Video Products Technical Bulletin 30-2015-021

SUBJECT: PARTS REGISTRATION—BEZEL FRAME

MODEL: **BVM-E170**
BVM-E170A
BVM-E170A
BVM-E250
BVM-E250A
BVM-E250A
BVM-F170
BVM-F170A
BVM-F170A
BVM-F250
BVM-F250A
BVM-F250A

Figure 1

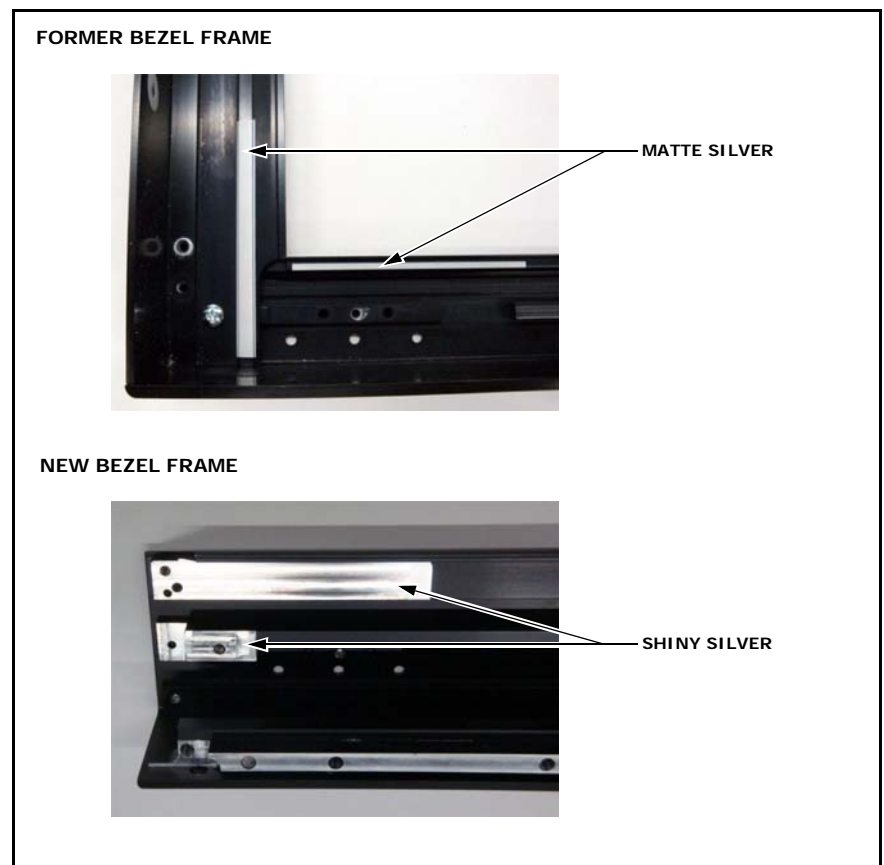
- Former and new bezel frames are not compatible. When replacing a former with a new bezel frame, replace all four bezel frames simultaneously.
- Former or new bezel frames may be used for BVM-E250 and BVM-E170. To distinguish between former and new bezel frames, check the silver strips on the rear of the frame. (See Figure 1.)
 - Former bezel frame: Matte silver strips
 - New bezel frame: Shiny silver strips with traces of machining
